Technical Service Bulletin: tsb100676

Released Date: 30-Jun-2008

New Cylinder Block and Piston Cooling Nozzles

Figure 1, Old Long Piston Cooling Nozzle (left) and New Long Piston Cooling Nozzle (right)

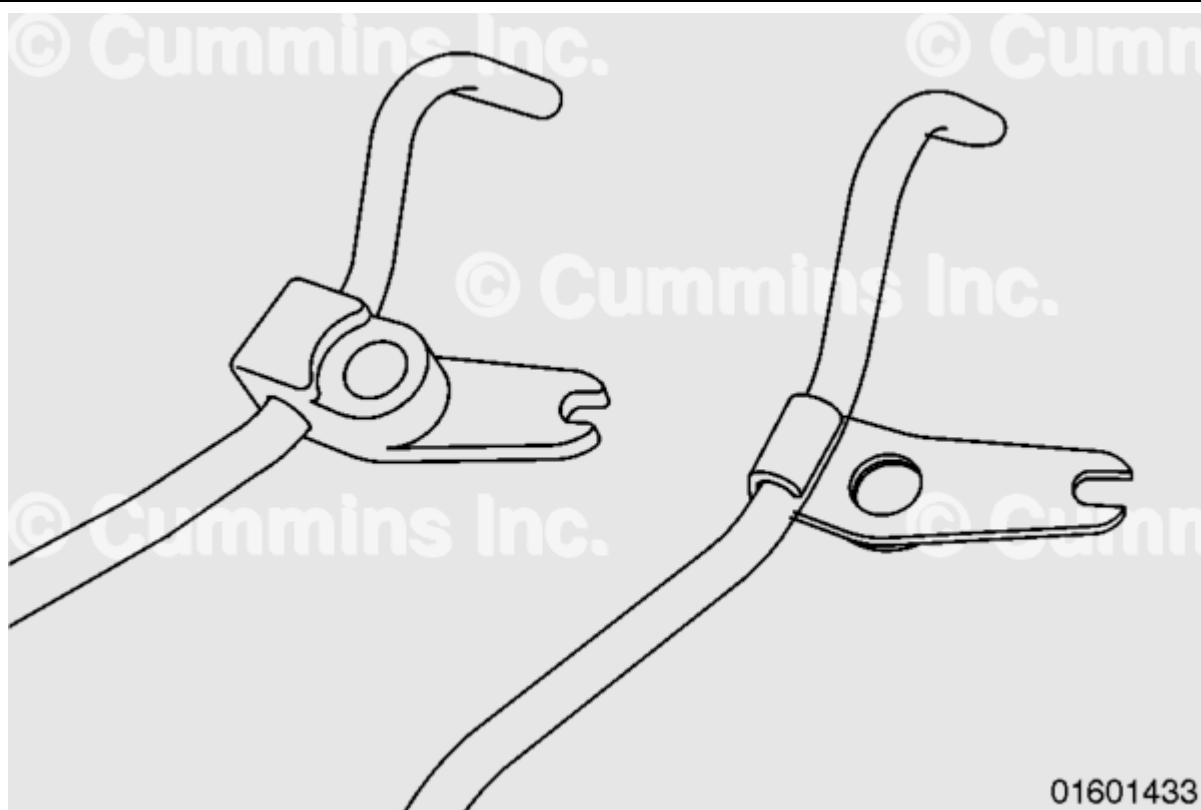
The new long piston cooling nozzle can be identified by the thinner mating surface near the nozzle end.

Figure 3, Old Banjo (1) and Center Bolt (2), New Banjo (3) and Center Bolt (4)

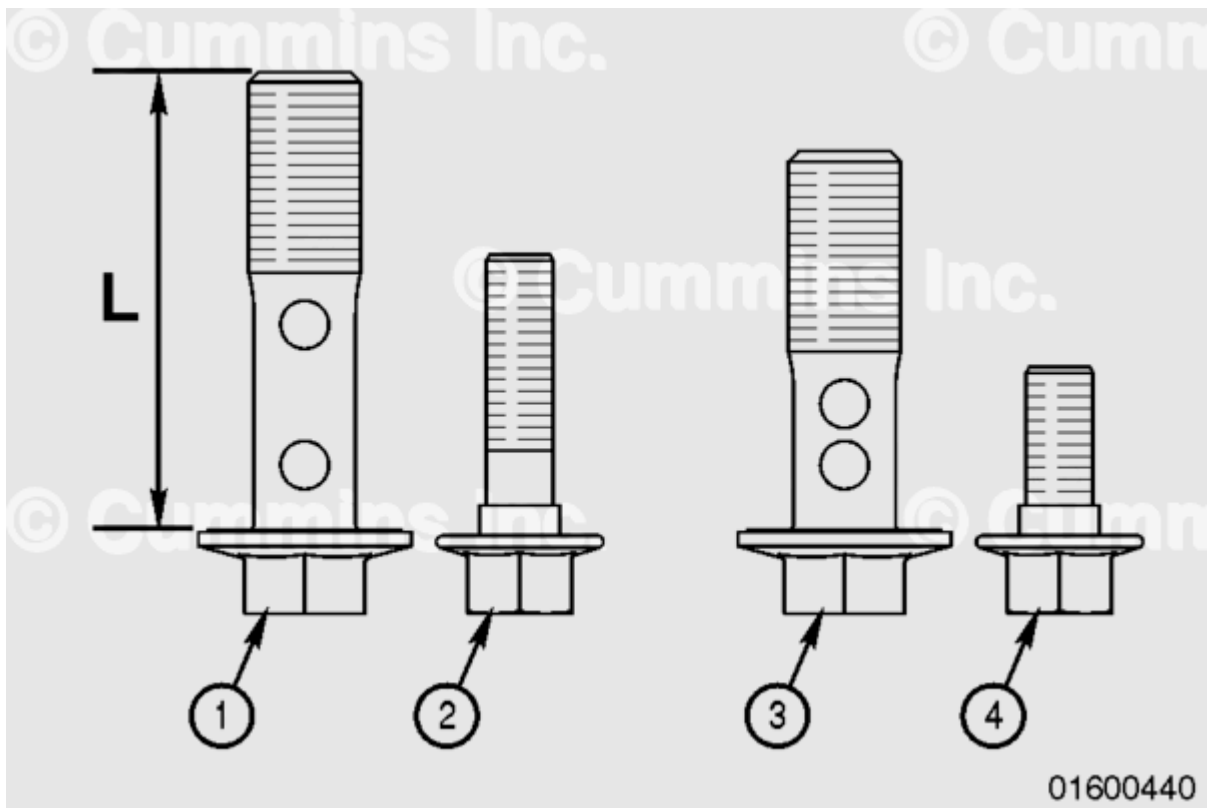
The new bolts are shorter than the previous bolts, as illustrated above.
